Service Bulletin

Category S	Applicable Model/s 1995-97 Millenia	Subject SUN ROOF LOWER PANEL COVER LOOSE	Bulletin No. 009/97 Issued 05/19/97 Revised
---------------	---	--	---

NOTE: Revision to Service Bulletin Cat. S 049/96

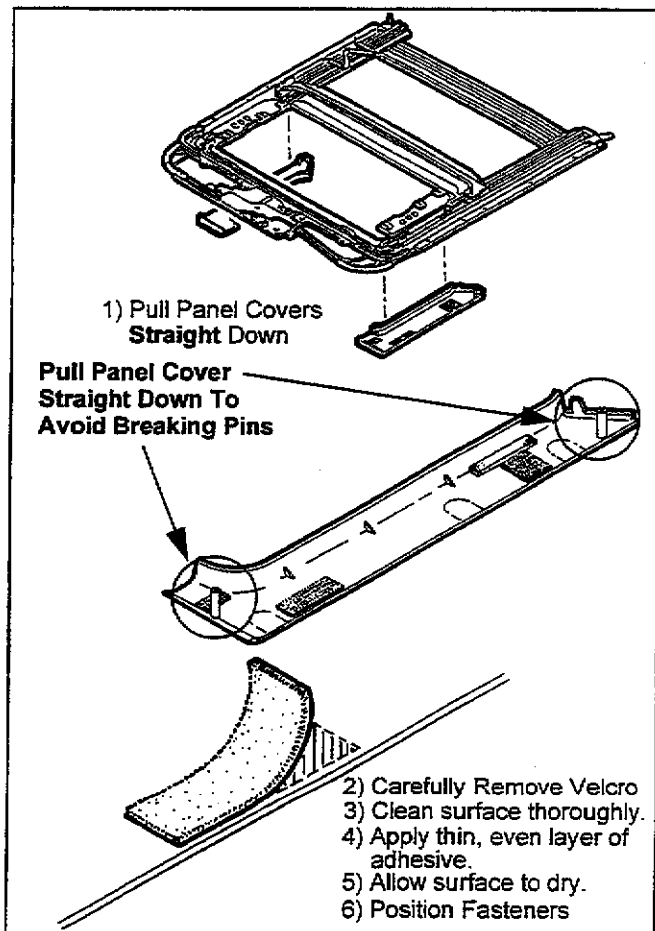
When the sun shade is opened, the lower panel cover may hang down. This is caused by insufficient adhesive holding the velcro fastener. To prevent peeling off, the velcro fastener is now installed on the lower panel cover by heating.

2. Remove all velcro fasteners from panels.

4. Apply thin even layer of adhesive to both velcro and panel cover with brush.

6. Position the velcro fastener on the lower panel cover and apply pressure to affix the fastener to the panel cover.
